**AusNet Services Revised Revenue Proposal  
2017-2022**

**Review of AusNet Services  
Transmission safety risk cost**

**Australian Energy Regulator**

**Energy Market Consulting associates**

Figure 8: Failure rates with variation of  $\beta$  (illustrative)

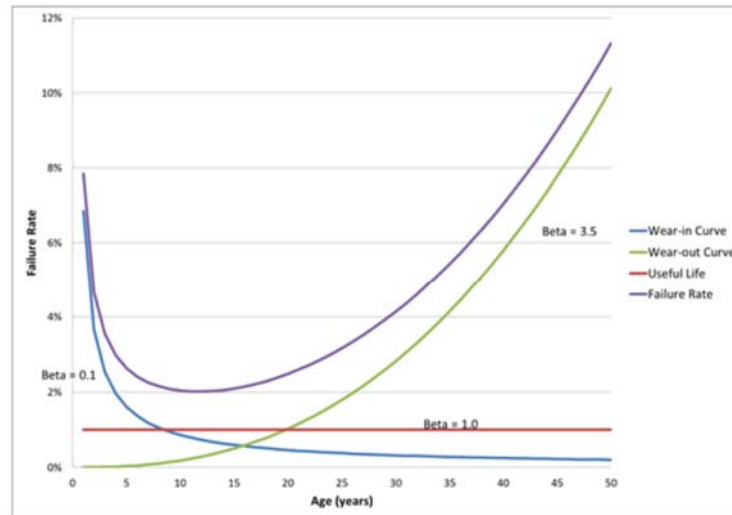
100. Whilst Figure 8 is illustrative,  $\beta = 3.5$  is representative of an ‘aggressive’ failure rate. AusNet Services has applied a constant  $\beta$  value of 3.5 to all asset classes in its reliability modelling. It states that its selection of  $\beta$  is “consistent with a wear out pattern represented by a normally distributed probability density function.”<sup>68</sup> AusNet Services has not demonstrated that the failure data for the assets under consideration are consistent with a normal distribution. We note for example, that the ages of instrument transformers suffering major failure in the Cigre international reliability study do not appear to follow a normal distribution.<sup>69</sup>

- 103. In lieu of such analysis, we consider that sensitivity studies using lower and higher  $\beta$  values are necessary to demonstrate that the ‘failure rates’ derived from the fixed  $\beta$  of 3.5 do not have a material impact on the outcome of the economic analysis. Since AusNet Services is using these distributions to assess the optimum replacement timing, the slope of the failure rate curve with time is important.

Figure 9: Power transformer major failure rates with condition score

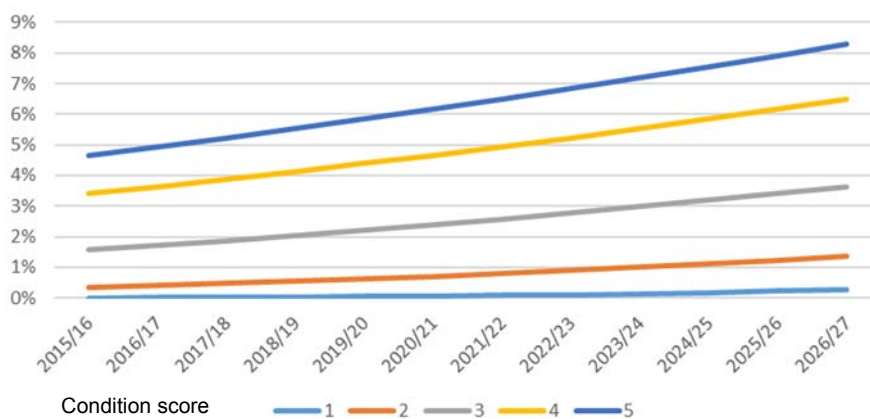
- 104. AusNet Services’ approach to deriving expected major failure rates (i.e. by including replacement rates) results in strongly increasing expected failure rates for power transformers, circuit breakers and instrument transformers (CTs and VTs) with poor (C4) or very poor (C5) condition scores. Figure 9 illustrates the results for power transformers used for the West Melbourne Terminal Station (WMTS) project. The curves are of a similar shape for circuit breakers, current transformers and voltage transformers.

Figure 10: AusNet Services' explosive failure to major failure ratio assumptions

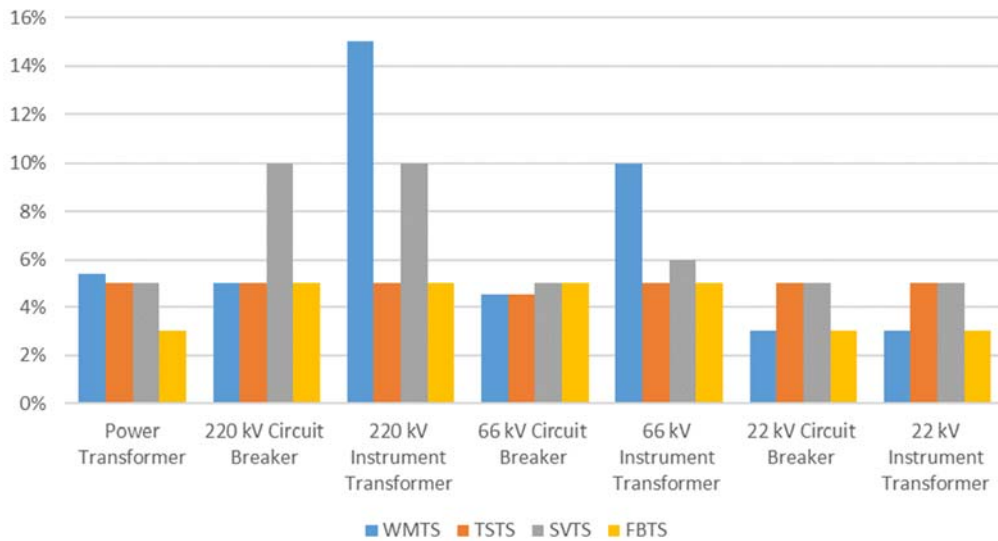
circuit breakers from an international study on the reliability of HV equipment.<sup>75</sup> The source of the ratios for 22kV equipment and for power transformers shown in Figure 10 is unclear.<sup>76</sup>

Figure 11: Number of explosive failures – AusNet Services' transmission network

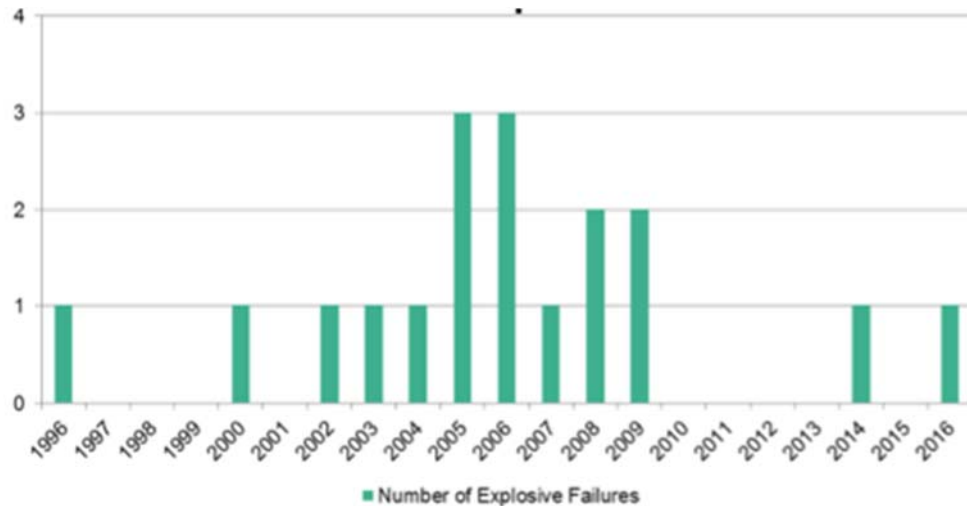
107. Figure 11 illustrates the actual number and temporal distribution of explosive failures AusNet Services has recorded over the last 21 years, including the most recent explosive failure of a CT at Richmond Terminal Station in 2016. On average, there has been an explosive failure approximately at a rate of 0.86 p.a. over this period. This equates to an annual failure rate of approximately 0.018% per device for AusNet Services' population of circuit breakers, instrument transformers, and power transformers.<sup>77</sup> This is an order of magnitude less than the annual explosive failure rate assumptions used in AusNet Services' economic models. For example, for condition 5 220kV CTs, the explosive failure rate in AusNet Services' model ranges from 1.00% in 2015/16 to 2.19% in 2026/27.<sup>78</sup> AusNet Services has not provided sufficient evidence of the reasonableness of the explosive failure rates projected for assets in the various asset classes.

108. AusNet Services' own data shows poor correlation between age and explosive failure. Although the 18 failures represent a small sample, the results from the international study conducted by Cigre show a similarly low correlation.
